Remarks

Applicant respectfully requests reconsideration and reexamination. The status of the claims is now as follows:

FIG. 3

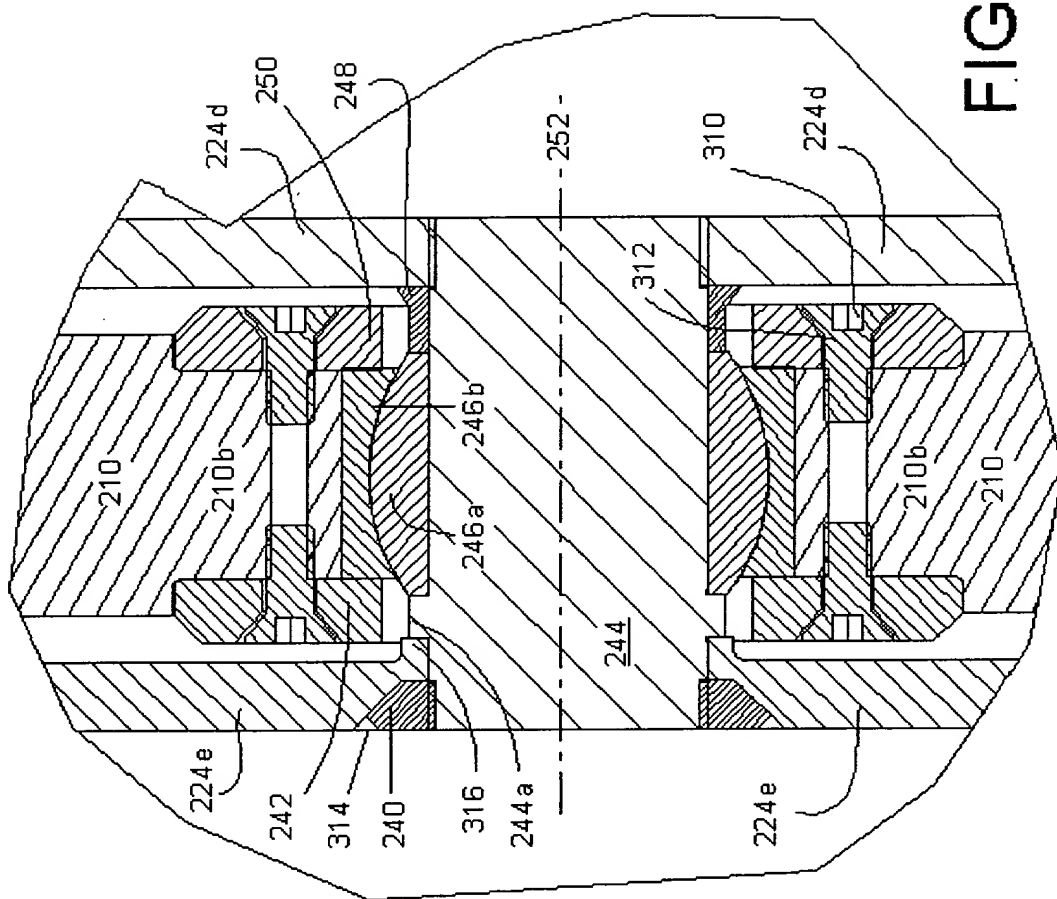
The Examiner has objected to the drawings because Fig. 3 shows only reference numerals, lead lines, and other seemingly random lines. This error was caused by an undetected software defect, wherein Applicants' CAD software failed to print an entire layer of the figure.

The Examiner has objected to the figures under 37 C.F.R. 1.83(a) for failing to show every feature claimed. In particular, the figures do not show "the lead screw engaging a threaded region of the elongated blade," as recited in claim 14. Although engagement of the lead screw with the elongated blade is consistent with the invention and falls generally within the scope of the claims, the Examiner is correct that the figures do not show this variation. Applicants' have canceled claim 14 to comply with the requirements of 37 C.F.R. 1.83(a). However, this cancellation is without disclaimer as to this variation and without prejudice to Applicants' right to claim this feature explicitly in a subsequent patent application that clearly shows the feature in the figures.

Applicants have supplied a complete Fig. 3, which now includes the previously missing layer. Although the content now shown in Fig. 3 was not initially provided, it is described in the specification as filed and can also be seen in the exploded view of Fig. 2. Therefore, no new matter has been added. A revised Fig. 3 is enclosed herewith, along with a separate letter to the Official Draftsperson.
